PLANS AND DOCUMENTS referred to in the
DEVELOPMENT APPROVAL

Application No: MCU/2021/603

MIXED-USE DEVELOPMENT

99 & 101 OLD BURLEIGH ROAD, BROADBEACH

DRAWING NUMBER
DA.101

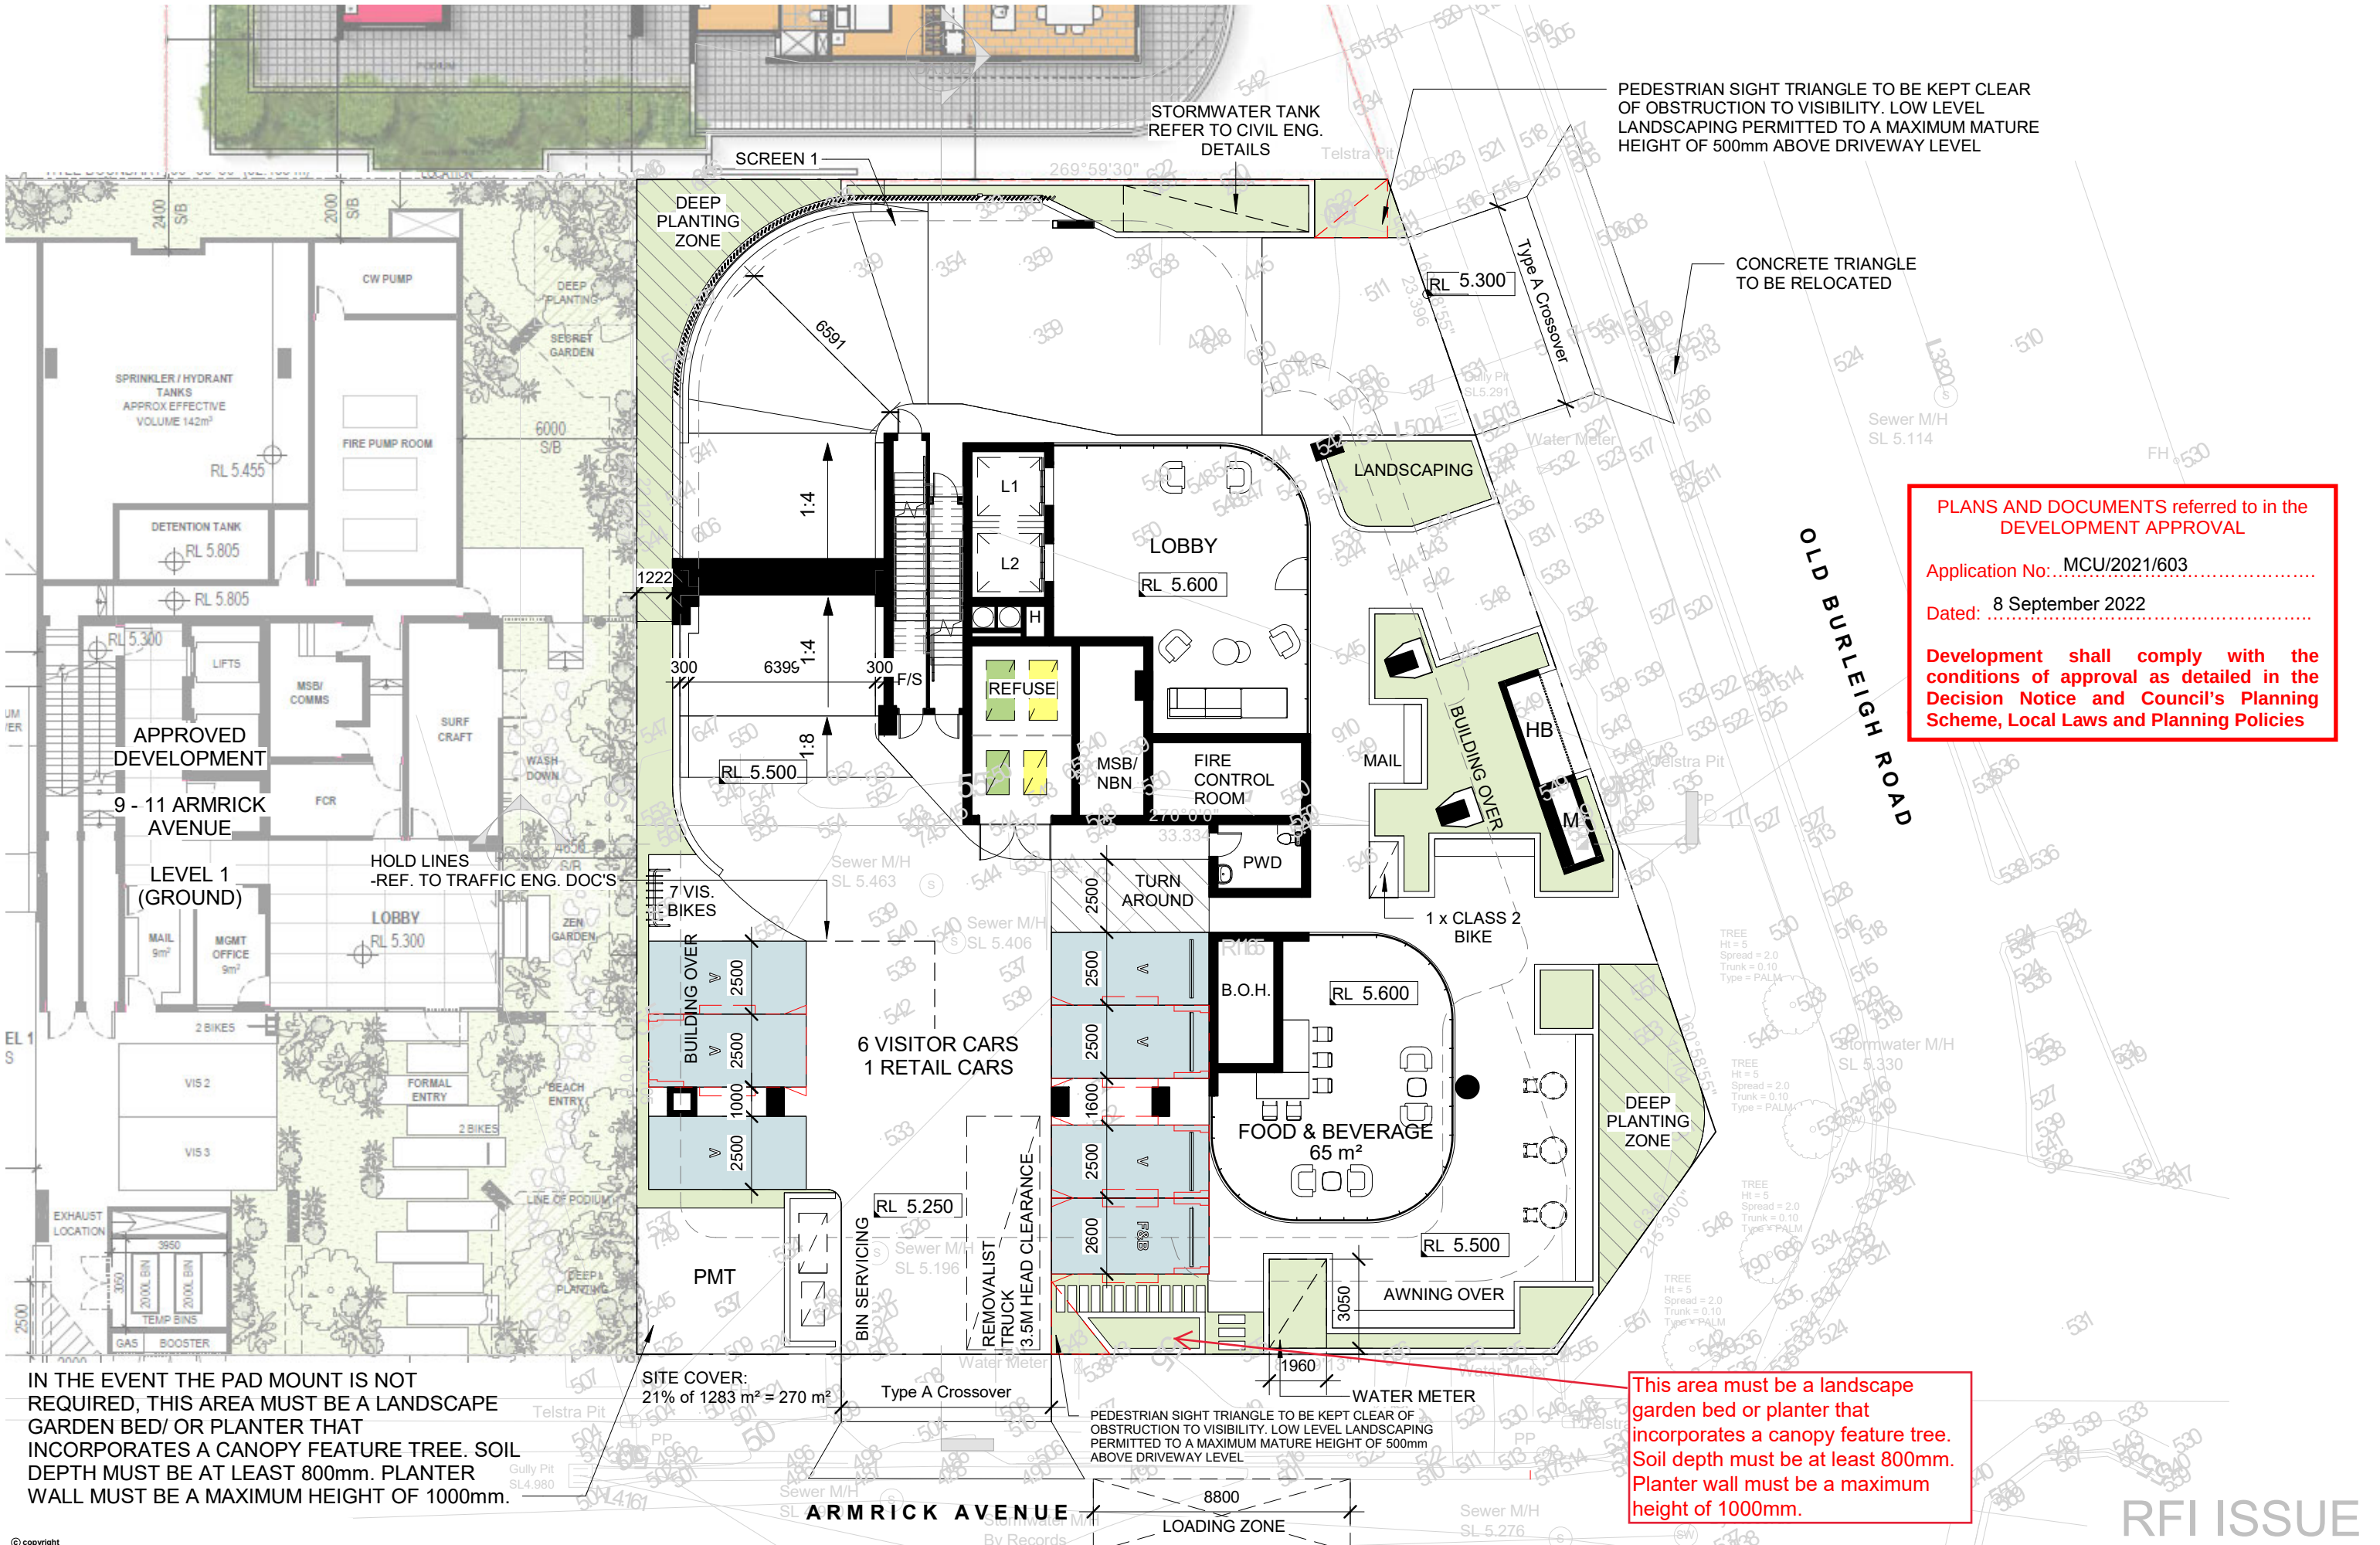
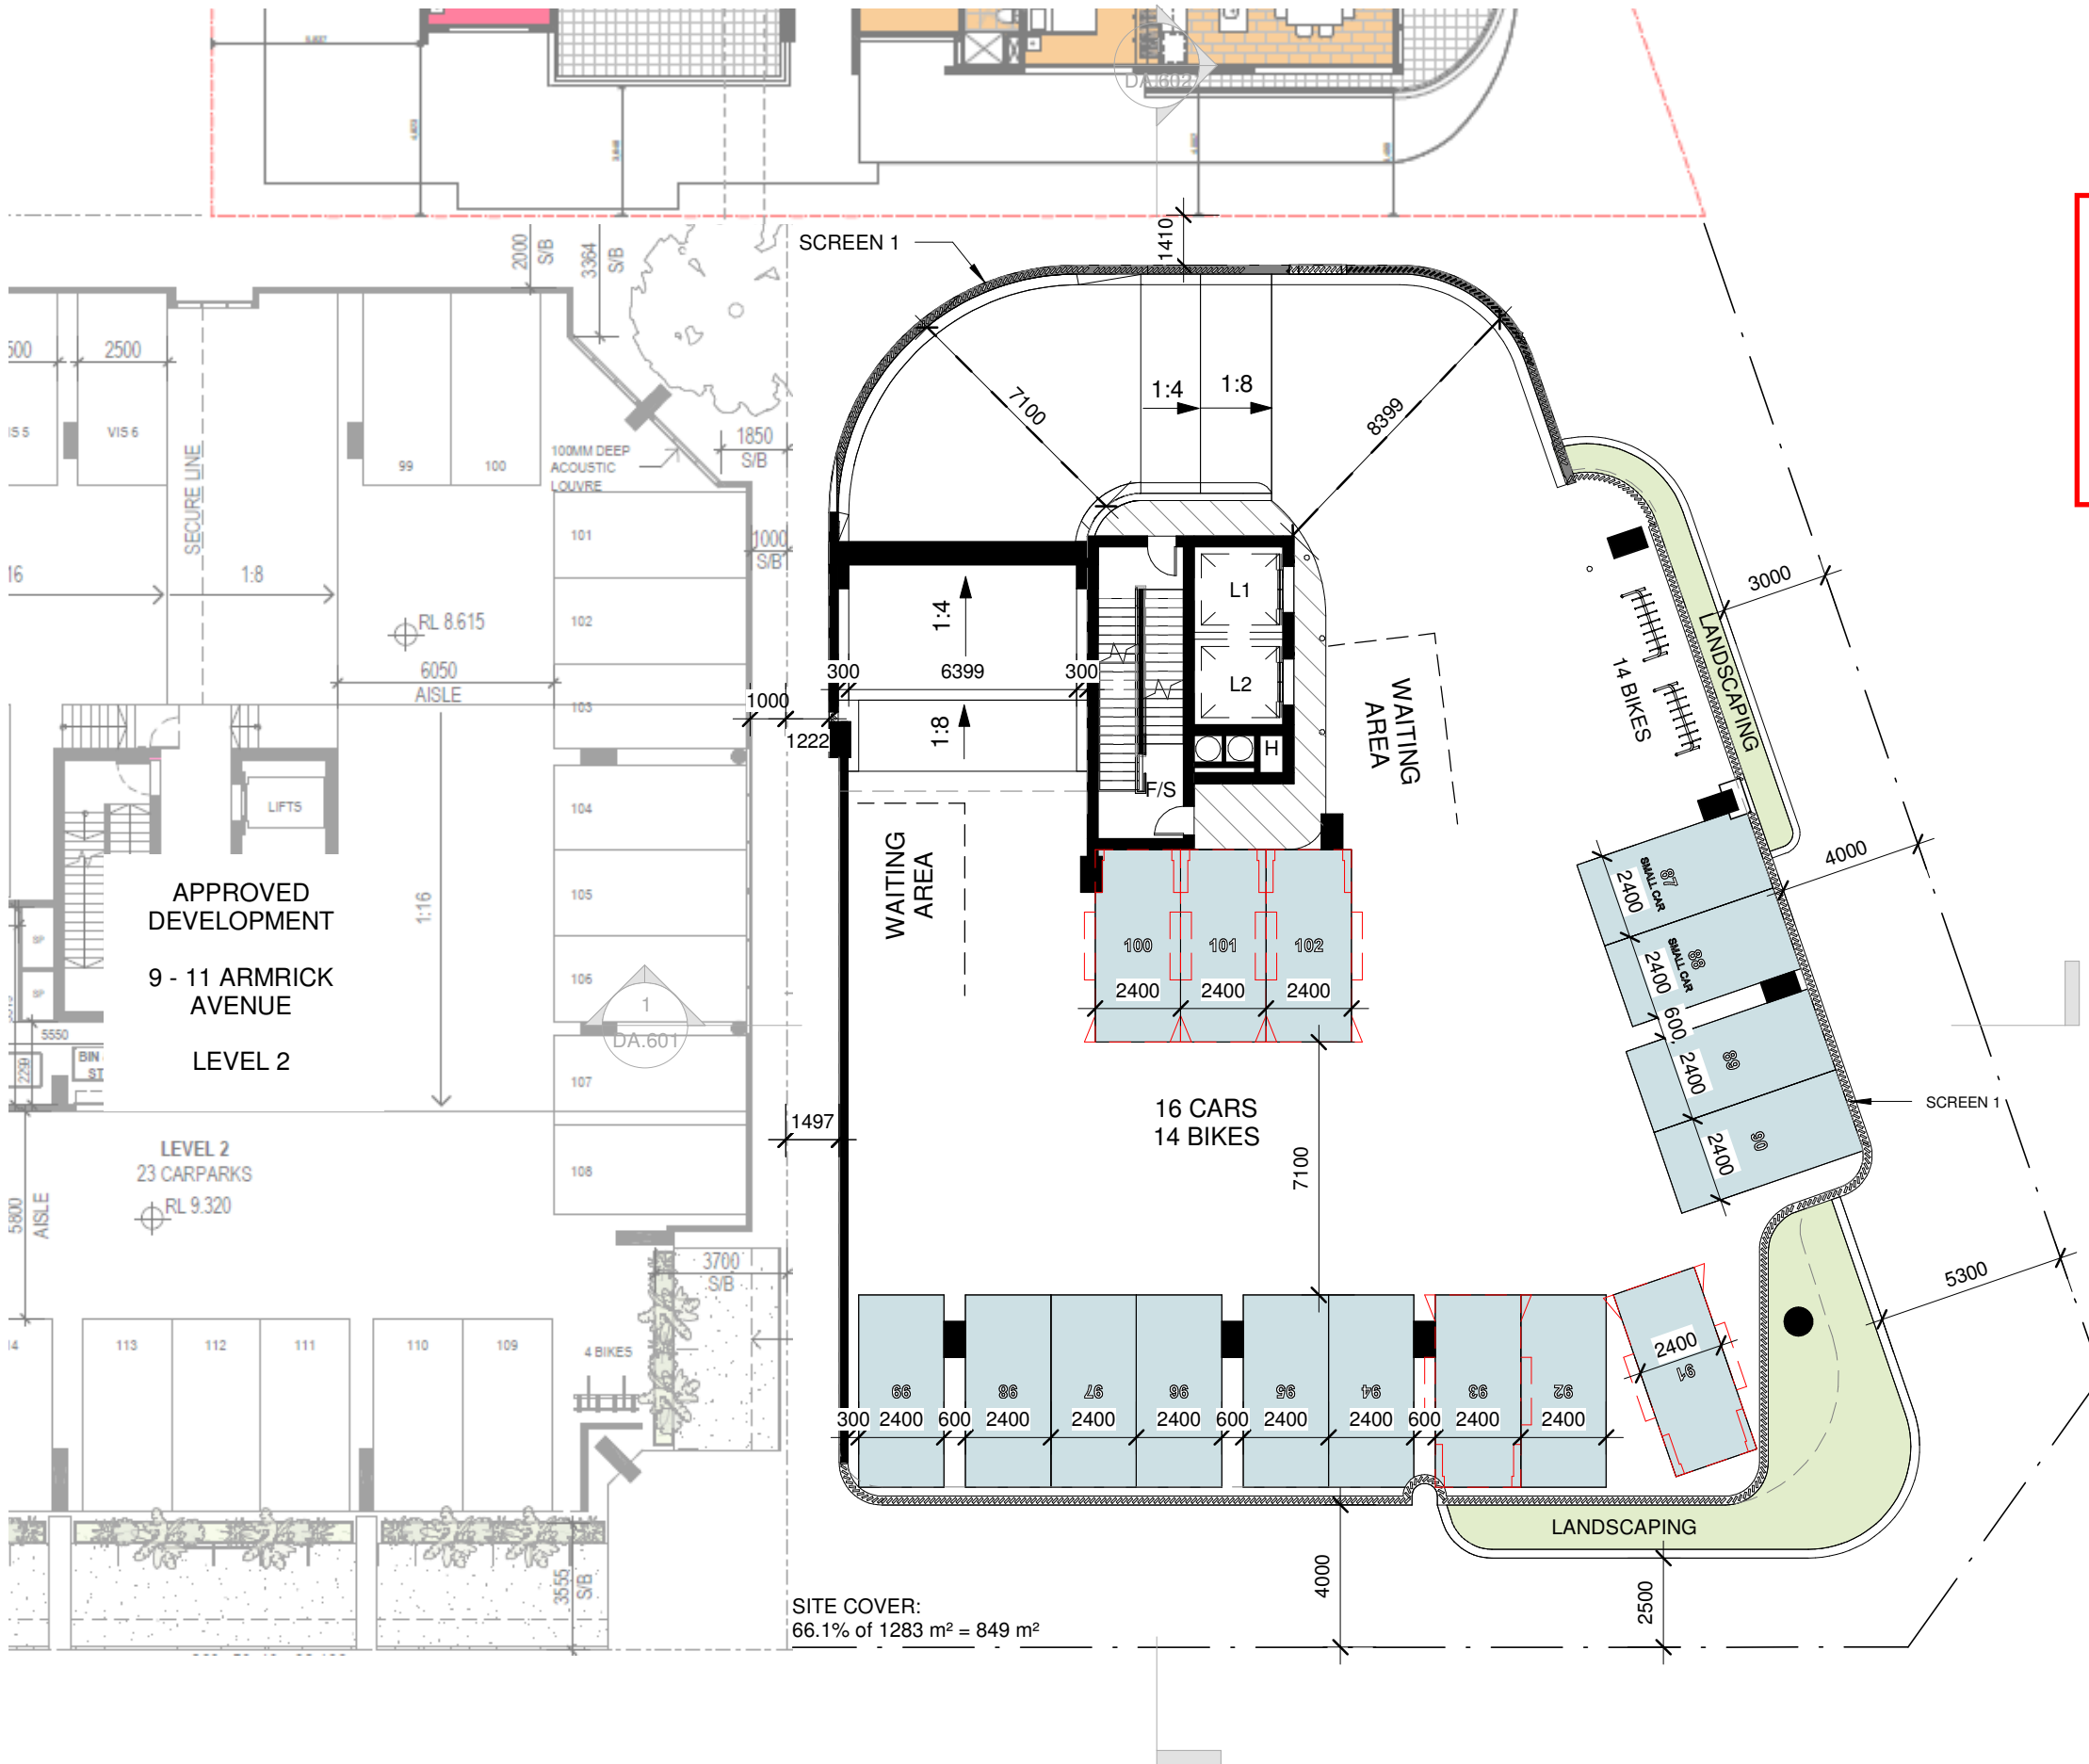
IN THE EVENT THE PAD MOUNT IS NOT REQUIRED, THIS AREA MUST BE A LANDSCAPE GARDEN BED/ OR PLANTER THAT INCORPORATES A CANOPY FEATURE TREE. SOIL DEPTH MUST BE AT LEAST 800mm. PLANTER WALL MUST BE A MAXIMUM HEIGHT OF 1000mm.

This area must be a landscape garden bed or planter that incorporates a canopy feature tree. Soil depth must be at least 800mm. Planter wall must be a maximum height of 1000mm.
